## District Planning Scheme No.2 Amendment No.58

MODEL CENTRE FRAMEWORK	PLANNING CONSIDERATION	PROPOSAL SUMMARY	COMMENT	QUESTIONS RAISED	
Centre Context	Regional Context	<ul style="list-style-type: none"> <li>• Statutory framework</li> <li>• Centre hierarchy</li> <li>• Catchment area</li> <li>• Neighbouring attractors</li> <li>• Strategic transport routes</li> </ul>	Consideration given to objectives of: <ul style="list-style-type: none"> <li>- Directions 2031</li> <li>- State Planning Policies</li> <li>- Metropolitan Region Scheme</li> </ul>	Appropriate planning consideration has been given to statutory framework, centre hierarchy and strategic transport.  Comment provided on catchment area and neighbouring attractors are contained in the Retail Sustainability Assessment (supporting document). This could be better demonstrated within the draft structure plan itself.	
	Local Context	<ul style="list-style-type: none"> <li>• Local policy context</li> <li>• Centre boundary</li> <li>• Demographic profile</li> <li>• Defining characteristics</li> </ul>	Consideration given to objectives of: <ul style="list-style-type: none"> <li>- DPS2</li> <li>- draft LPS</li> <li>- draft LHS</li> <li>-

Figure 5.1.3 : Proposed Character Areas

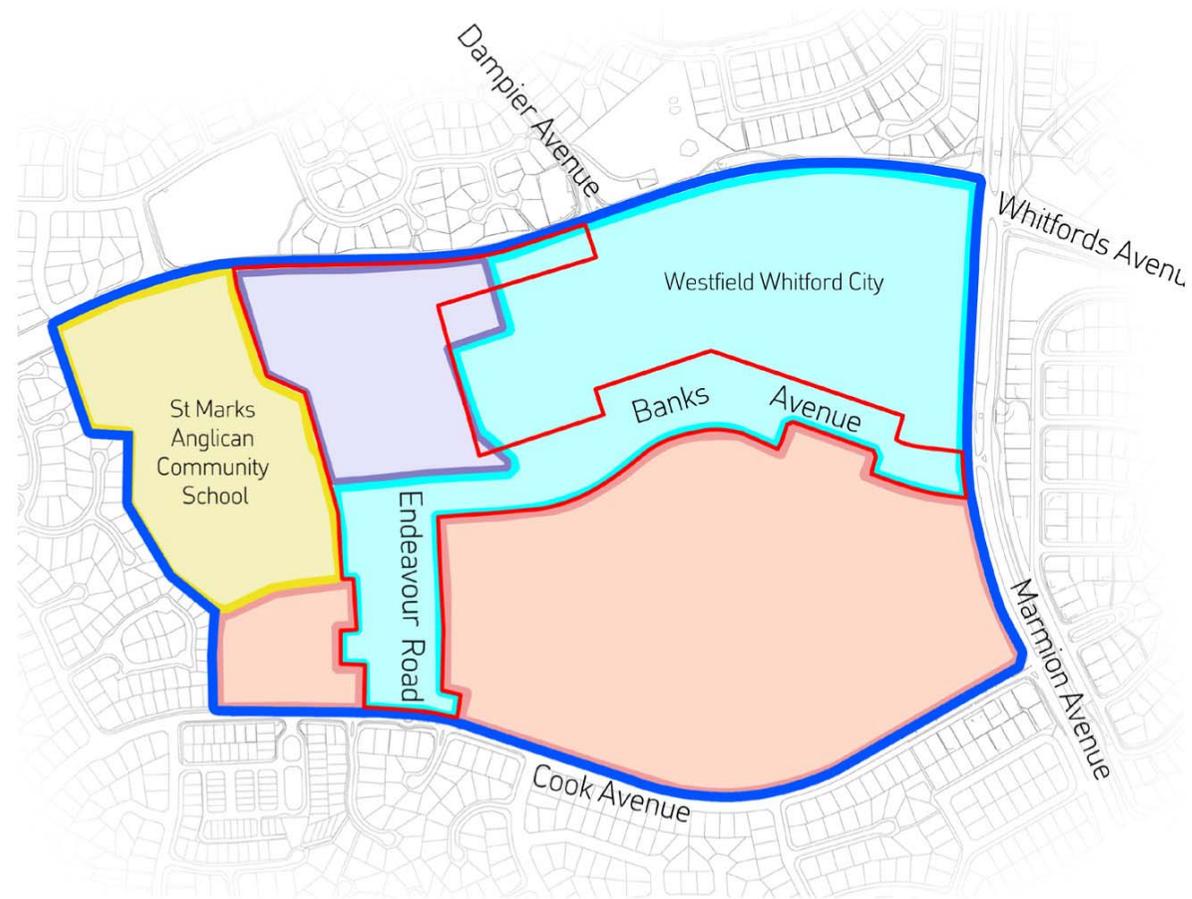
CHARACTER AREA		PROVISION	COMMENT ON STATUTORY PROVISIONS
CORE		<p>Building Height</p> <p>Tallest buildings close to the town square on Endeavour Road (12-14 storeys)</p> <p>Three storeys at the street, with podium levels setback from the street to provide solar access and appropriate scale.</p>	<p>Significant change from existing urban form, however the building heights may be required to achieve the 'Intensity' and 'Diversity' targets set out in the Activity Centre Policy.</p> <p>A proposed 14 storey development within the WAC area is significantly larger than any development currently planned for the Joondalup City Centre.</p> <p>It is anticipated that there may be a strong community reaction to the proposed building heights.</p> <p>Three storey street level development is considered appropriate.</p>
		<p>Building Typologies</p> <p>Sleeving to large format buildings.</p> <p>Podium apartments.</p> <p>Integrated buildings at street level (minimum 3 storey).</p> <p>Articulated facades, detailed finishes.</p>	<p>Inadequate information is provided to make an assessment against this statutory provision.</p> <p>Proposed building typologies consist of sound planning principles.</p>
